**St Margaret's Chambers**  
For Charlotte Street Estates

Piccadilly Elevation -  
Proposed Repairs and  
Conditions

| drwg no. | <b>P(206)</b> |

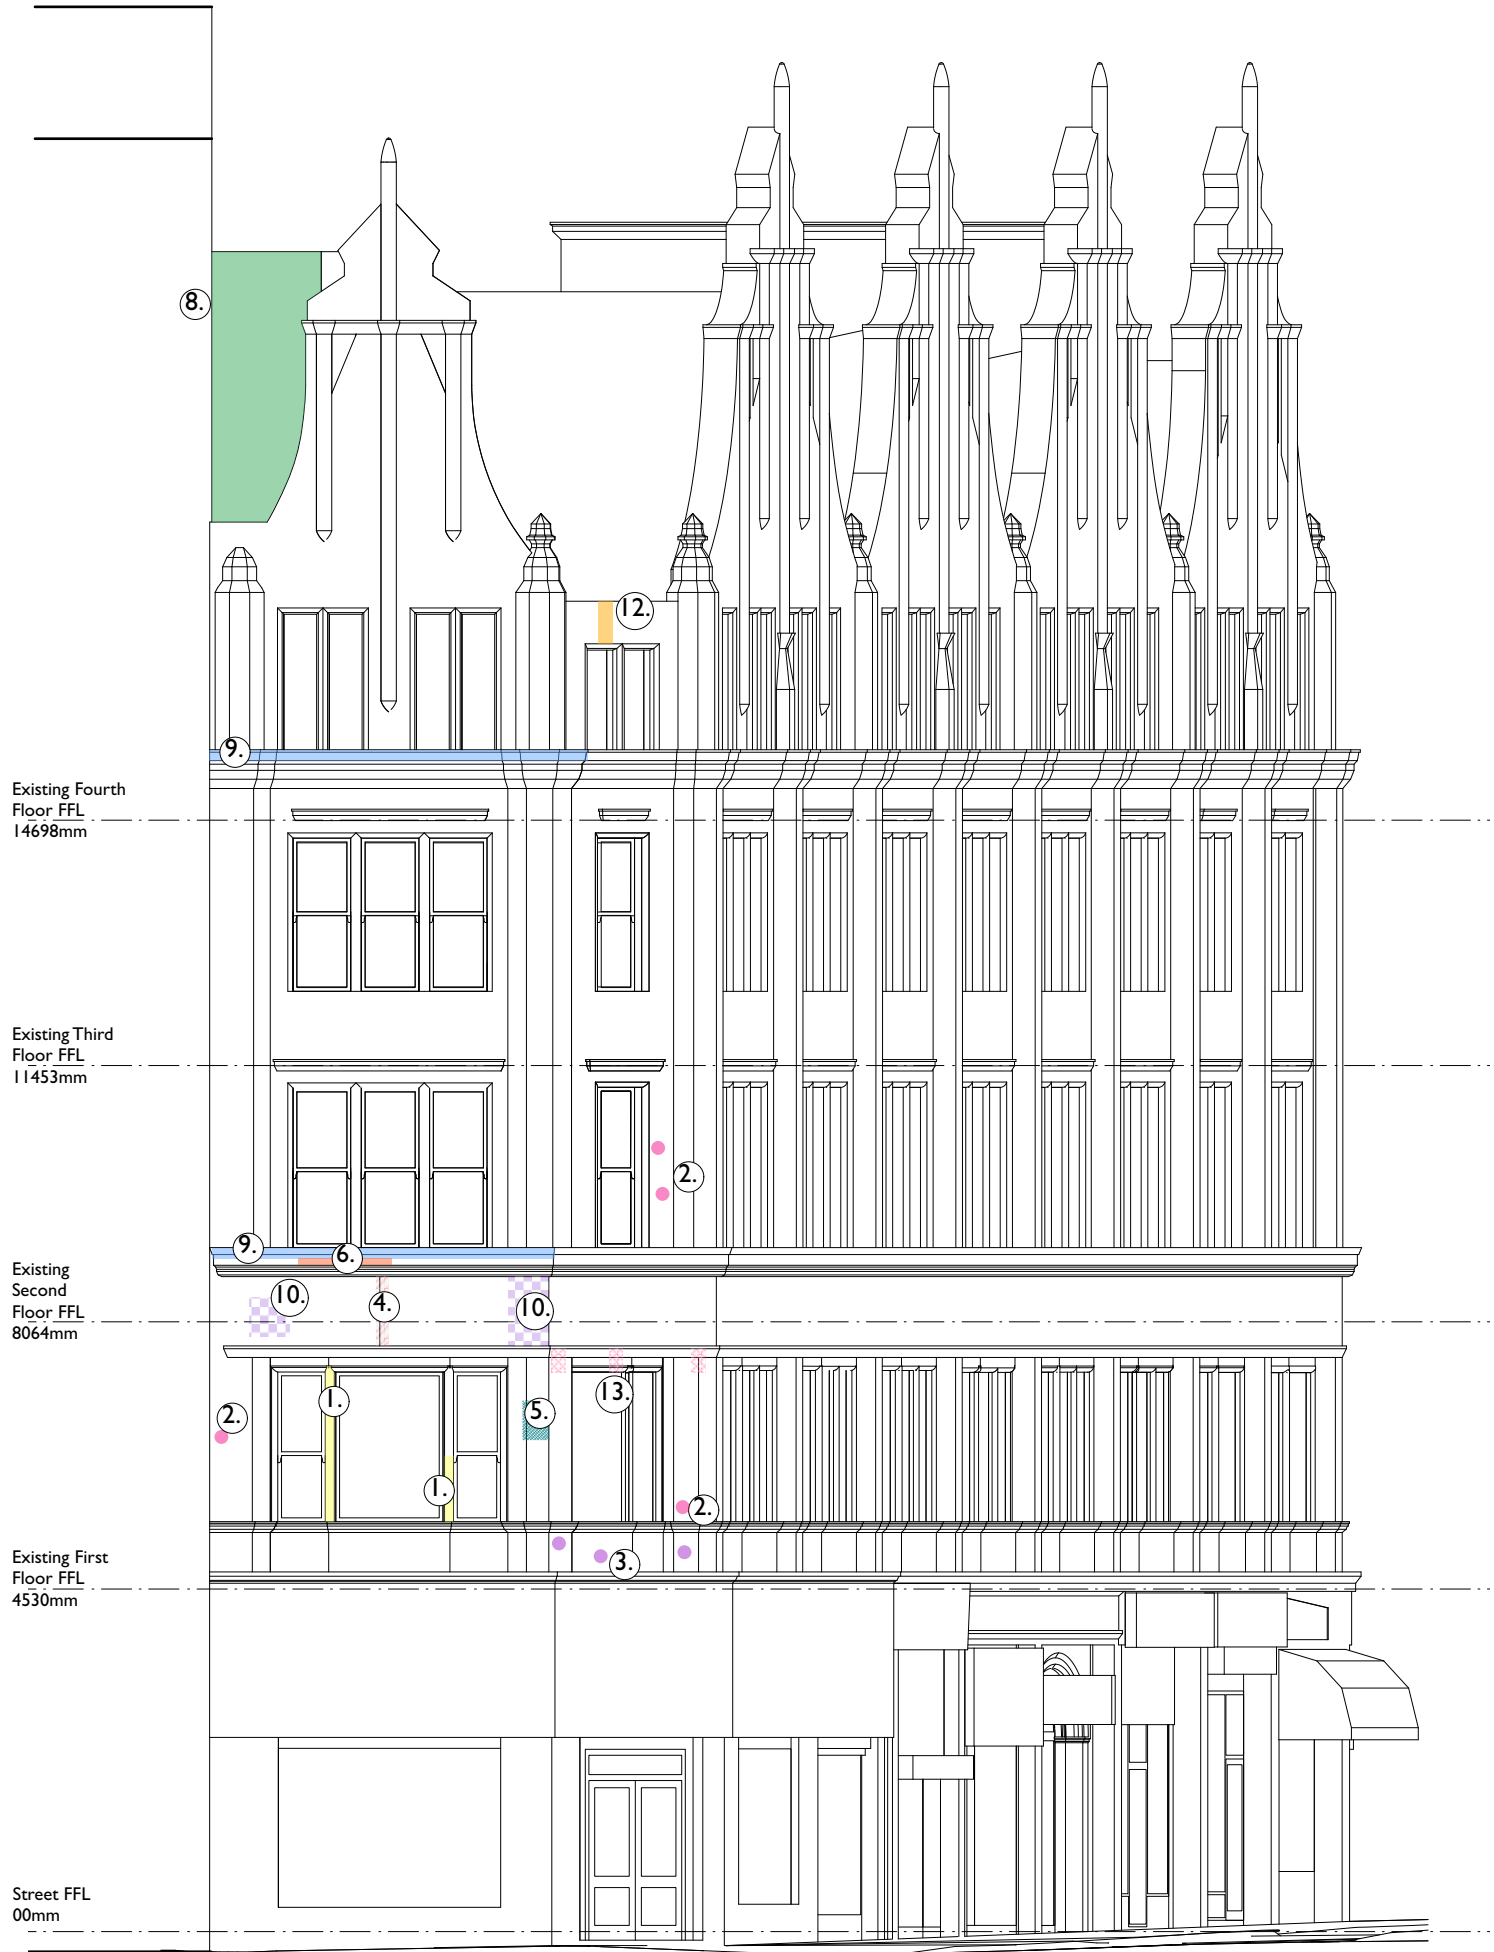
- 1 Sandstone erosion - close inspection required.
- 2 Holes left by redundant fixings - mortar fill in accordance with specification.
- 3 Gaps in brickwork. Close inspection required to inform replacement with matching material.

- 4 Missing pointing between frieze panels. Reinststate in accordance with specification.
- 5 Redundant plant equipment carefully remove and make good fabric in accordance with specification.

- 6 Eroded sandstone coping. Close inspection required. Replacement matching stone inserts may be required to prevent further deterioration.
- 7 Rusting lintels Clean off and repaint in accordance with specification.

- 8 Biological growth to be removed from roof level.
- 9 Coping water staining. May require repointing. Close inspection required.
- 10 Previous repairs to sandstone. Poorly matched aesthetic and presumed composition, but no evidence repairs are causing damage to surrounding historic fabric. Add to building maintenance plan for regular monitoring.

- 11 Biological growth to stone to be cleaned in accordance with specification.
- 12 Water staining may be caused by missing pointing. Close inspection required to inform repair strategy.

- 13 Signs of cracking. Further inspection required on site.
- 14 Redundant cables/lights/alarm box. Carefully remove
- 15 Residue from former sign to be cleaned off sandstone. Method pending site trials.

General atmospheric dirt to masonry faces. No sign of causing damage to underlying fabric. Propose no action.

Flashings to be renewed as required
